DATE: August 18, 2023
TO: Blue Bird Owners
Subject: RECALL R19AI – Service Brake Switch Bracket Deformation on Driver Control Module

SUBJECT: RECALL R19AI – Service Brake Switch Bracket Deformation on Driver Control Module

R19AI – Ford Service Brake Switch Bracket Deformation

Figure 1

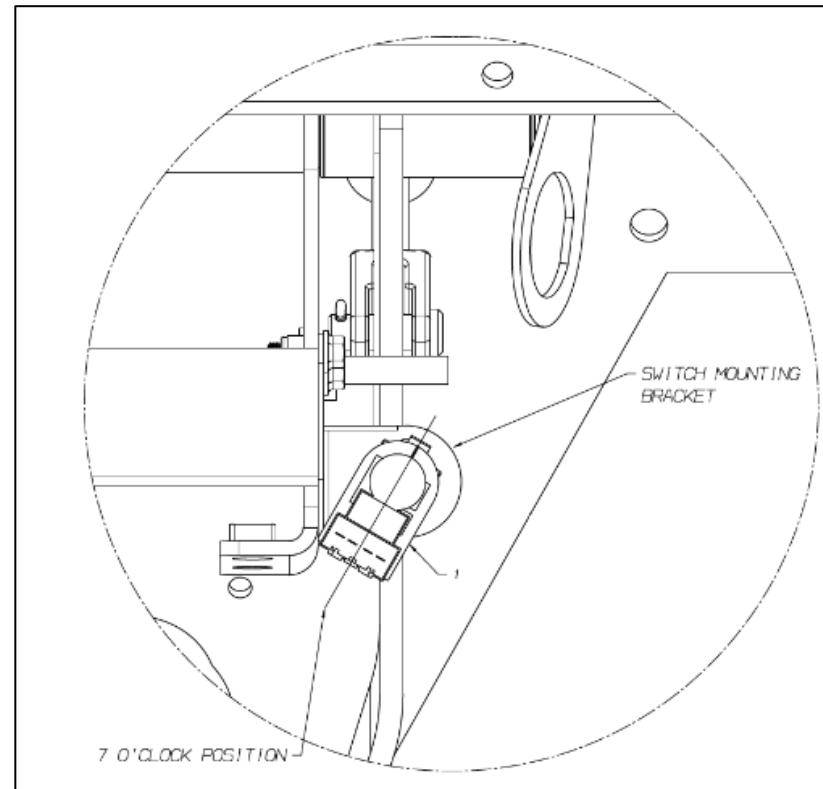
1. Locate service brake switch in front of driver's area, above brake pedal arm.
2. Disconnect the electrical connector from the service brake switch.
3. Rotate the service brake switch clockwise to the 7 o'clock position, and remove. (Figure 1)
The switch will not be reused, it should be marked as bad and discarded.

Figure 2

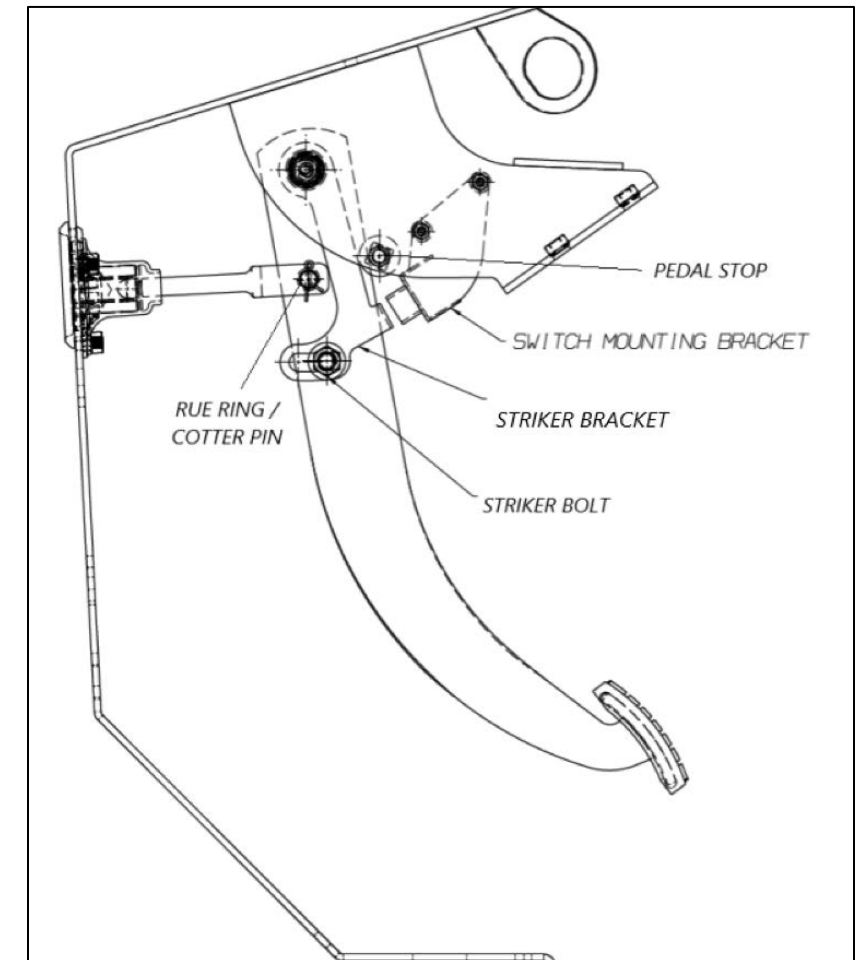
4. Remove the two fasteners mounting the switch mounting bracket to the steering column housing. Retain the mounting fasteners. *The switch bracket will not be reused, it should be discarded.* (Figure 2 and 3)

5. Remove and retain the E-Clip, nut and washer from brake pedal pivot shaft (Figure 3)
6. Remove the rue ring (or cotter key) and clevis pin from yoke/brake pedal (Figure 2)

7. If necessary, back off the pedal stop (threaded bolt) from steering column bracket to allow free motion of the brake pedal. (Figure 2)
8. Rotate brake pedal fore and aft, as necessary, while sliding to the right until removed from pivot shaft. (Figure 3)

Figure 3

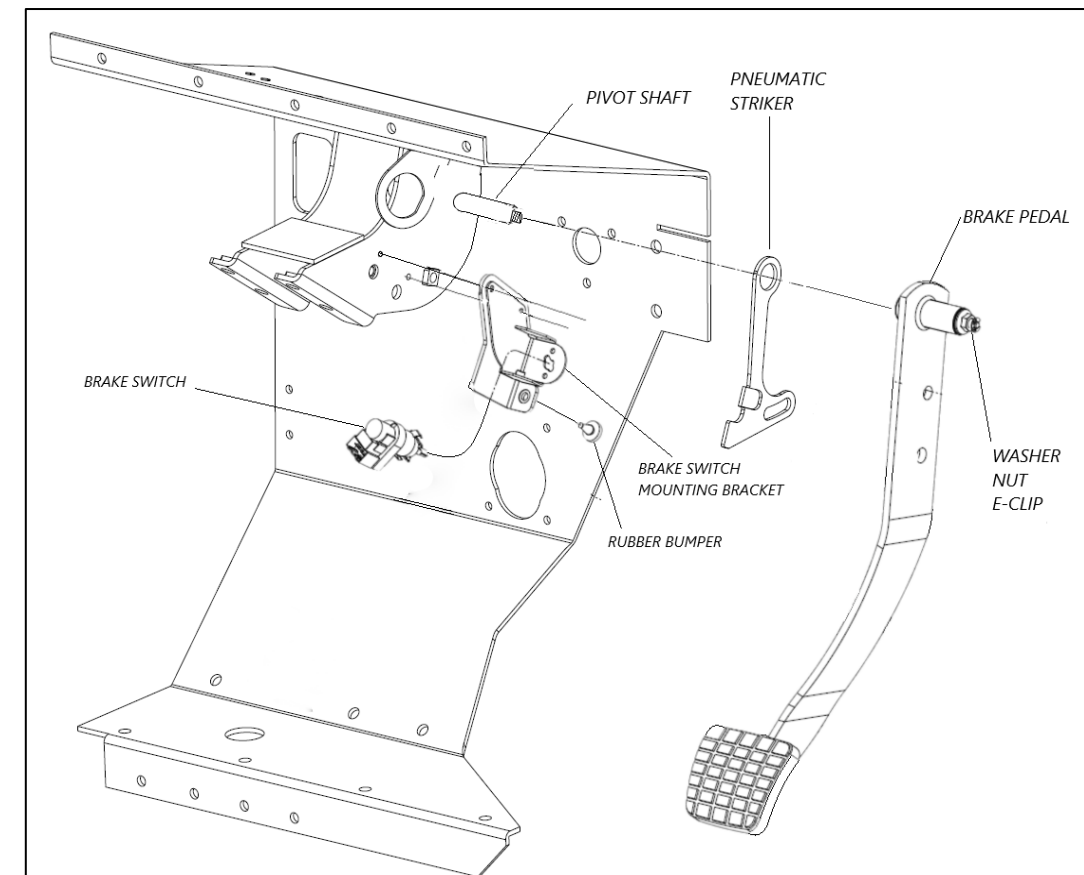
9. Remove striker bracket from brake pedal assembly. (Figure 3) Retain the 1/2" striker nut, bolt and washers, as they will be reused.
The striker bracket will not be reused, it should be discarded.
